Technical Bulletin

Number: 077
Date Issued: 08/23/2010

| Subject/Key Words: | Series 4 PCs; Monitor Image Shift/Flicker; Correct Display Settings | | | |

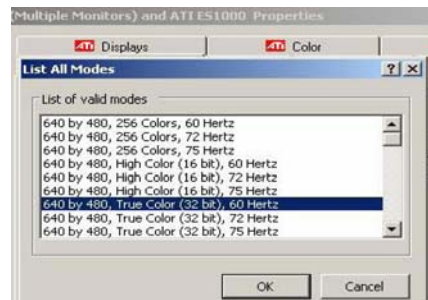
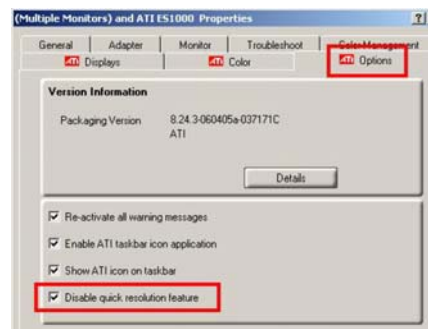
Suspected Cause: The resolution mode was mistakenly set to 640 by 480, True Color (32 bit), 75 Hz. The 75 Hz setting causes the User Interface monitor display to shift to the right and also introduces screen “flicker”.

Scroll through the selections and highlight the option that reads 640 by 480, True Color (32 bit), **60 Hz**. Click OK.
